RE: Fair Oaks and Howe Retail (P15-079)

WALKSacramento has reviewed the project routing for Fair Oaks and Howe Retail (P15-079) distributed by the City of Sacramento. We offer the following comments on the project with the goal of creating a more walkable and healthy project within the City of Sacramento.

Figure 2: Loading Dock Driveway Entrance Crossing

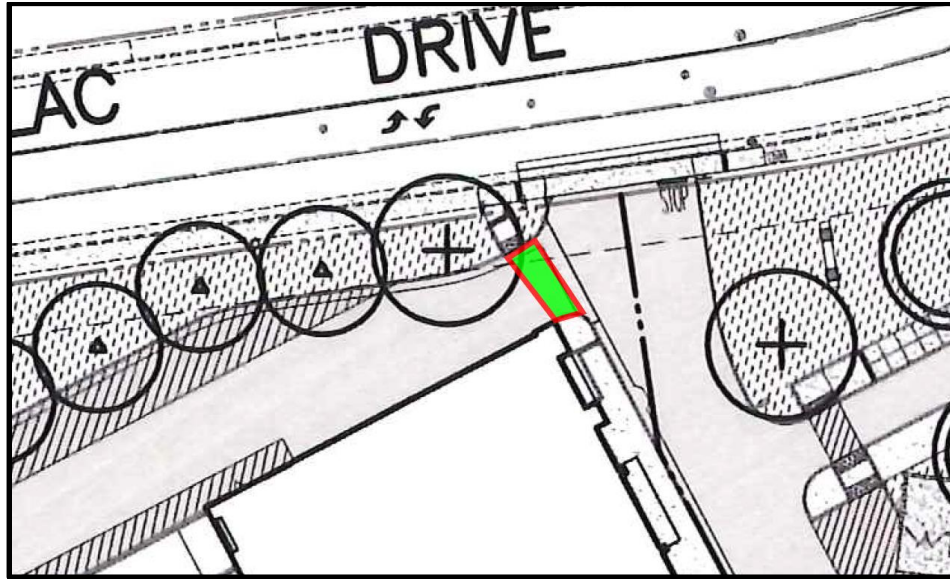
Access to the site from Cadillac Drive (north) requires crossing the loading dock driveway entrance but there's no crosswalk nor is there a curb ramp on the south side. See the green-shaded area in Figure 2 below. **WALKSacramento recommends adding a marked crosswalk at the loading dock driveway entrance and a curb ramp on the south side to improve pedestrian safety and mobility.**

Figure 3: Pathway Between "Grocery" and "Outparcel"

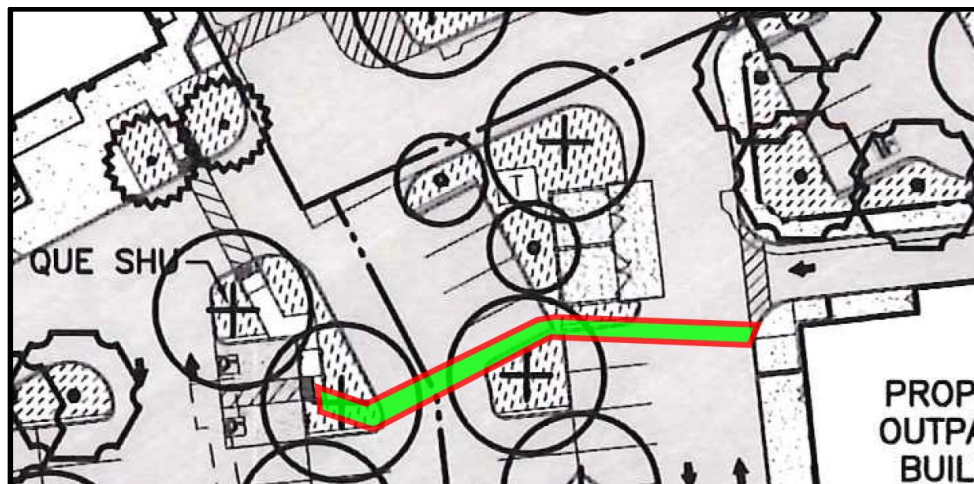
Access to the "Outparcel" access from Cadillac Drive (north) is somewhat indirect. There is an opportunity to add additional access between the "Outparcel" and "Grocery" buildings by adding marked crosswalks and sidewalks in the planters next to the trash/recycle enclosure and the "Grocery" ADA parking spaces. See the green-shaded area in Figure 3, below. **WALKS**acramento recommends adding crosswalks across two drive aisles and sidewalks in the planters next to the trash/recycle enclosure and the "Grocery" ADA parking spaces to improve pedestrian safety travelling between the "Outparcel Building" and the "Grocery."

Figure 4: Enabling "Park Once" and Access from Cadillac Drive (west)

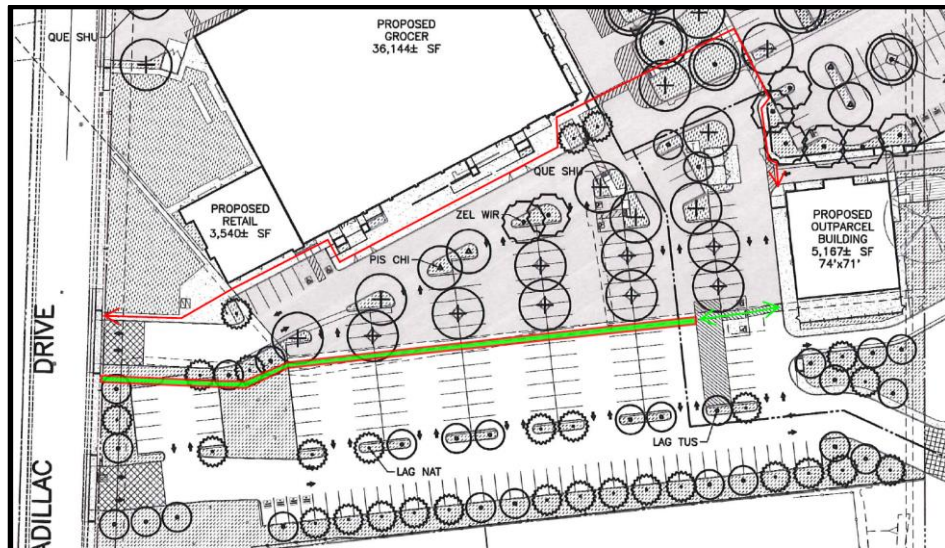
The following recommendation is made to enable more "park once" shopping and improve access to the "Outparcel Building" from Cadillac Drive (west). "Park once" reduces the number of vehicles circulating in the lot at one time, but it also reduces cold starts and idling as drivers look for a second place to park. Figure 4 shows a potential marked walkway between Cadillac Drive (west) and the "Outparcel Building" indicated by a green shaded area. This walkway would not only provide access from the street that is much more direct than the route allowed by the proposed site plan, indicated by a red line in Figure 4, but it would also provide a convenient path from the "Grocery" parking field to the "Outparcel Building" and CVS. Shoppers would have a safer east-west path using a marked walkway to cross drive aisles than if they were walking between spaces and parked cars. It may also provide shoppers easier access to cart corrals and reduce the number of corrals needed by providing openings through the parking rows.

WALKSacramento recommends adding a walkway with marked drive-aisle crosswalks between Cadillac Drive (west) and the ADA parking spaces near the southwest corner of the "Outparcel Building."

Figure 5: Trees for Visual and Acoustical Screening

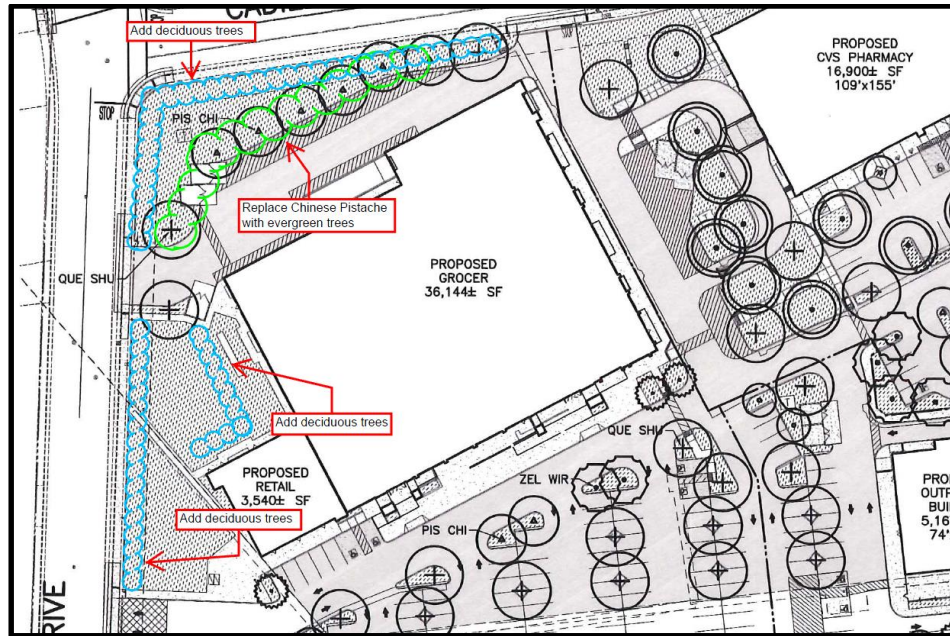
The last two recommendations are to improve the pedestrian experience at the street and reduce the visual and acoustical impacts of the "Grocery/Retail" building. The elevations of the north side and west side of the "Grocery" provide little interest to pedestrians. There are no windows providing "eyes on the street", except for the southwest corner of the small retail space next to the "Grocery", and the walls are mostly blank and have little articulation. This presents an uninteresting view, especially during the winter when the deciduous trees are leafless. Planting evergreen trees along the loading dock driveway can reduce the visual and acoustical impact of the loading dock; planting deciduous trees in the space to the west of the west wall can reduce the visual impact of the building.

WALKSacramento recommends moving the Chinese Pistache shown along the loading-dock driveway to the back of sidewalk, and planting evergreen trees along the driveway to visually and acoustically screen the northern wall of the building and the loading dock.

WALKSacramento also recommends planting deciduous trees close to the back of sidewalk and near the west side of the "Grocery/Retail" building to visually screen the building.

Figure 6: Marked Crosswalk at South Leg of Cadillac Drive and Feature Drive

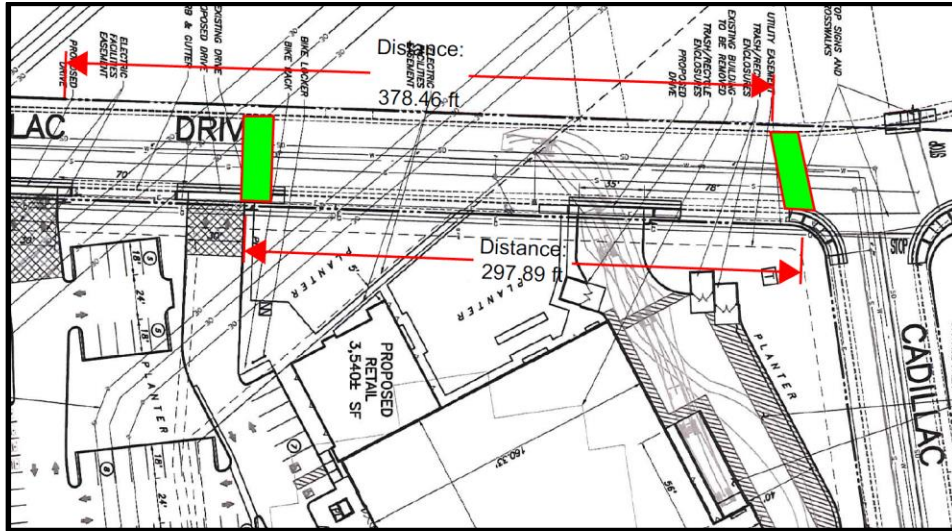
Finally, pedestrian trips beginning or ending from the senior housing directly across Cadillac Drive or the townhomes and apartments to the south will not have a convenient marked crossing. The crosswalk shown on the drawings will take pedestrians a minimum of about 600 feet out of their way to get to the driveway access to the shopping center. The choice between crossing midblock or walking 300 feet away from one's destination and then returning 300 feet does not encourage choosing the safe and "accessible" route.

A marked crossing at the driveway may be justified, and may require traffic calming and pedestrian enhancements considering many of the pedestrians may be elderly. Additionally, a marked crosswalk at the south leg of the Cadillac Drive and Feature Drive intersection on the site plan and planting plan will be needed to encourage safe crossings to the shopping center. See Figure 6 for these two locations.

WALKSacramento recommends adding a mid-block marked crossing at the Cadillac Drive (west) driveway and at the south leg of the Cadillac Drive and Feature Drive intersection.
